LR-N05-0397
LCR S05-07

**REQUEST FOR CHANGE TO TECHNICAL SPECIFICATIONS TO REVISE
STEAM GENERATOR TUBE SURVEILLANCE REQUIREMENTS IN
ACCORDANCE WITH WCAP-14797, REVISION 2 (W* METHODOLOGY)
SALEM GENERATING STATION - UNIT 2
DOCKET NO. 50-311
FACILITY OPERATING LICENSE NO. DPR-75**

**CHANGE TO TECHNICAL SPECIFICATIONS TO REVISE STEAM GENERATOR
TUBE SURVEILLANCE REQUIREMENTS IN ACCORDANCE WITH WCAP-14797,
REVISION 2 (W* METHODOLOGY)**

Sketch of W* Distance in Salem Unit 2 Steam Generator Tube Sheet

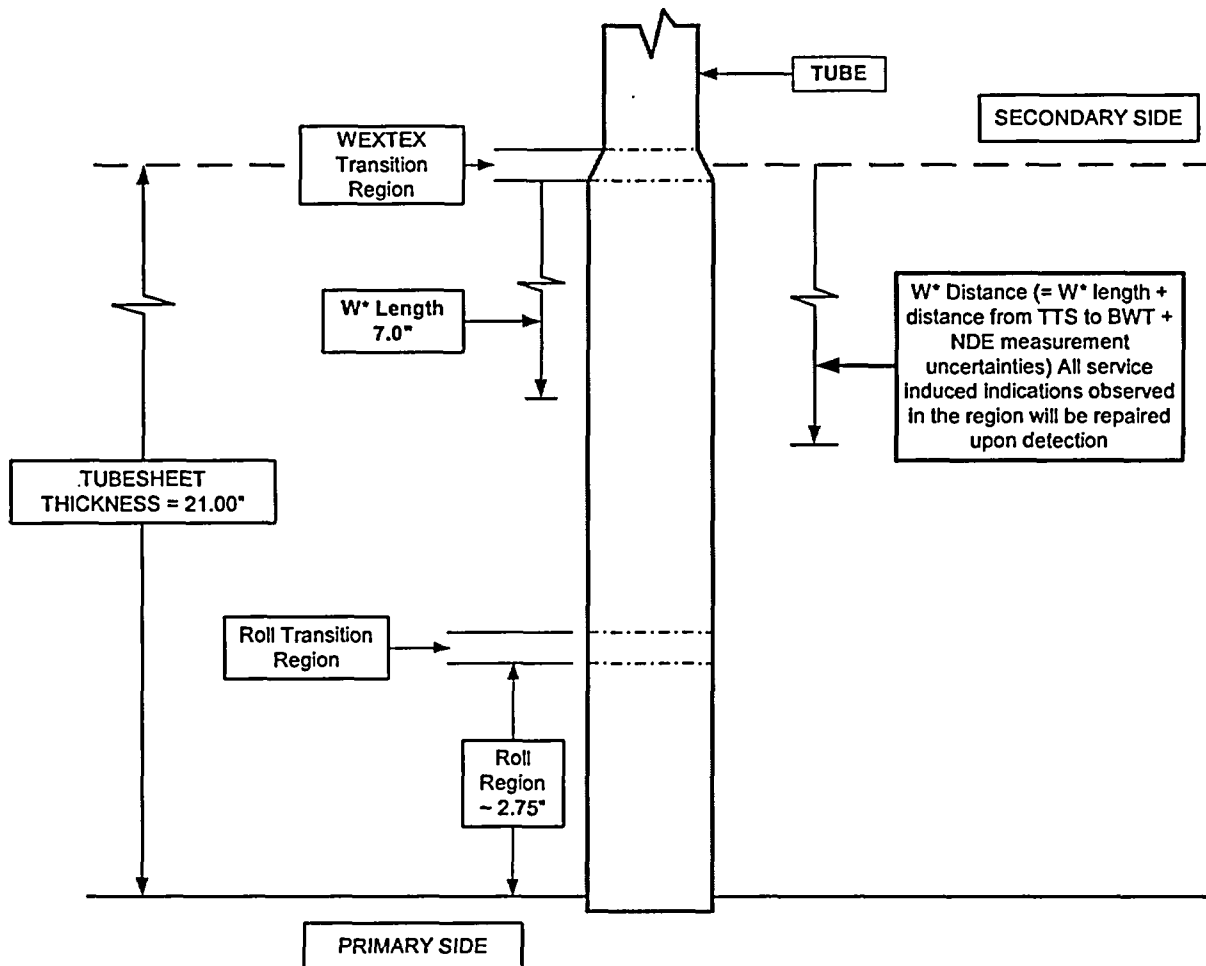
For the Salem Unit 2 Westinghouse Model 51 Series SGs with WEXTEx expansions, the full depth tube-to-tubesheet expansion can be defined as follows: from the lower tube end and extending upward for a length of approximately 2.75 inches is a region expanded by a tube rolling expansion process, from the top of the rolled expansion region to the vicinity of the TTS the expansion joint was produced by the WEXTEx process. The resulting full depth tube-to-tubesheet expansion can be considered as four distinct areas. These are described in WCAP-14797 Revision 2 and depicted in the sketch on the following page as:

1. The Roll Region – The tube region that has been expanded by the tube rolling process. This region extends from the bottom of the tube to approximately 2.75 inches above the bottom of the tube.
2. The Roll Transition – The tube region that extends from the roll expanded region to the initially unexpanded region, which is subsequently expanded by the WEXTEx process.
3. The WEXTEx Region – The tube region explosively expanded to be in contact with the tubesheet. This region starts at the roll transition and extends to the WEXTEx transition in the vicinity of the tubesheet top.
4. The WEXTEx Transition – The tube region that acts as a juncture between the WEXTEx region and the unexpanded tube region. The region starts at the top of the explosively expanded region and extends for approximately 0.25 inches.

The alternate SG tube repair criteria, referred to as W*, were developed by Westinghouse to permit tubes with predominantly axially oriented primary water stress corrosion cracking in the WEXTEx and hardroll regions to remain in service. The W* analysis determined the W* length as measured from the bottom of the tube explosive expansion transition that would permit flaws below that length to remain in service. This is based on adequate strength available to

BWT – The bottom of the WEXTEx Transition is defined in WCAP-14797, Rev. 2, as approximately 0.25 inches from the top of the tubesheet.

W* length – The maximum length of tubing below the bottom of the WEXTEx transition (BWT) which must be demonstrated to be non-degraded and is defined in WCAP-14797, Rev. 2, Section 4.0 as 7.0 inches below the bottom of the WEXTEx transition on the hot leg side.

W* distance – The distance from the top of the tubesheet to the bottom of the W* length including the distance from the top of the tubesheet to the BWT and measurement uncertainties.

1. All service-induced indications within the W^* distance must be removed from service by tube plugging.
2. Any type or combination of tube degradation below the W^* distance is acceptable.
